Service Bulletin

Bulletin No.: PIP4554J

Subject: Clunk Noise After Shifting From Reverse To Drive Or Drive To Reverse And Then Accelerating

Models: 2007-2009 Cadillac SRX
2007-2011 Cadillac STS
2008-2013 Cadillac CTS
2010-2013 Chevrolet Camaro
RWD only, equipped with 6L45 or 6L50 (RPO MYA, MYB) Automatic Transmission

2610907

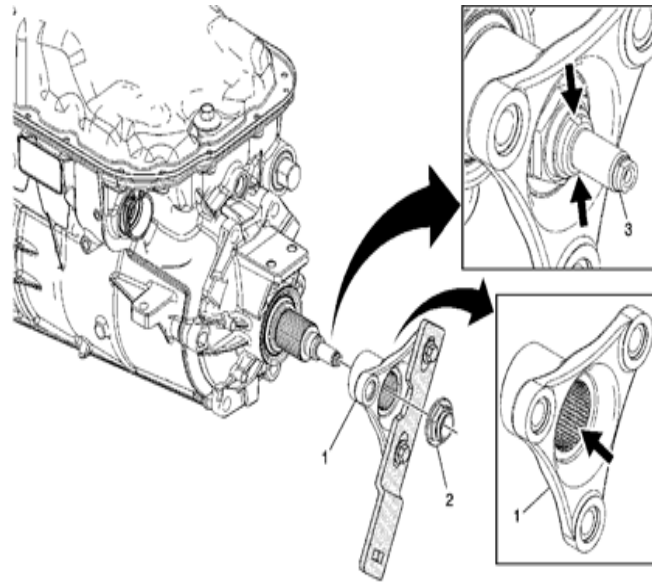
This condition may be caused by the torque on the propeller shaft flange nut or movement between the flange and the transmission output shaft.

Apply thread locker to the transmission output shaft flange splines and a new front propeller shaft flange nut following the procedure below.

The existing output shaft and output shaft flange can be re-used and does not require replacement. A new front propeller shaft flange nut should be used.

1. The output shaft flange splines must be thoroughly clean and dry before installing the flange.

Note: When repairing low speed and garage shift clunk - except for moving the vehicle from the hoist, do not operate the vehicle above 5 mph at light throttle for 24 hours to allow the adhesive to cure.

2. Apply GM P/N 89021297 (Canadian P/N 10953488) evenly across the width and length of the flange splines and install the flange onto the transmission output shaft.
3. Sufficient application of adhesive to every tooth on the flange will leave excess adhesive on the output shaft after installation. If no excess is observed, reapply adhesive. Remove excess adhesive.

1. The output shaft nut threads must be thoroughly clean and dry before installing the nut.
2. Apply GM P/N 89021297 (Canadian P/N 10953488) across the width of the nut threads, prior to tightening and staking.

Note: If the replacement nut contains a pre-applied adhesive patch, then liquid adhesive is not required.

Tighten 55 N·m (41 lb ft).

Caution: Stake the flange nut onto the output shaft. Use the two staking grooves on the shaft to locate the staking points. Failure to stake the flange nut may result in damage to the transmission.
